**Re: *Response to April 4 Information Request*
 *Supplement to Waterfront Development Permit Application***

On April 4, NJDEP requested the following information to issue a conditional approval of the Waterfront Development Permit for the River Mile 10.9 Time Critical Removal Action (RM 10.9 Removal Action) on the Lower Passaic River.

Mr. A. Cinque
RM 10.9 Removal Action – Supplement to Waterfront Development Permit Application
April 10, 2013
Page 2 of 5

Sieve Size % Passing for sand to be used as top layer of cap at RM 10.9 Removal Area

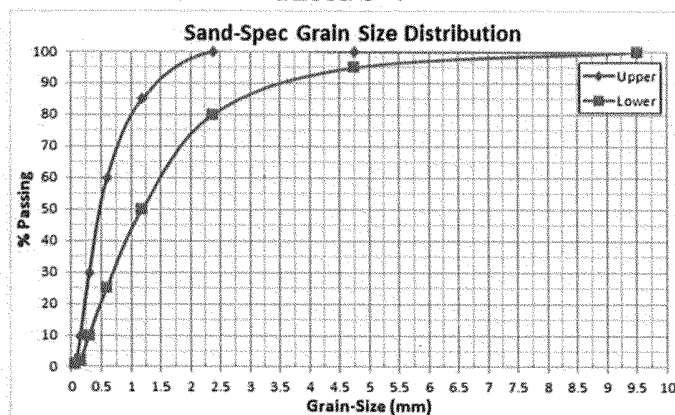
3. Statement or calculation with supporting data indicating that the cap's sand cover on top of its armoring layer has a roughness coefficient similar to or less than that of the existing sediment, further justifying the conclusion that the Removal Action will not increase flooding potential on the Passaic River

Request 3: The RM 10.9 Removal Area cap will be smoother in terms of roughness than the existing sediment based on specifications for the sand cover, as follows.

The cap will be covered with "medium to coarse" sand (see following table and chart).

Source of all Manning Coefficients used in the following analysis: United States Geological Survey (USGS, 1984) "Water-supply Paper 2339 - Guide for Selecting Manning's Roughness Coefficients"

- Firm soil in a stable channel and flood plain such as exists in the RM 10.9 Removal Area of the Lower Passaic River has a Manning roughness coefficient of 0.025 – 0.032.
- The sand specified for the RM 10.9 Removal Area cap will have a median diameter in range of 0.5 to 1.2 mm with an equivalent 0.022 – 0.027 Manning roughness coefficient.

Because there is no increase in surface roughness, there is no increase in flooding potential.
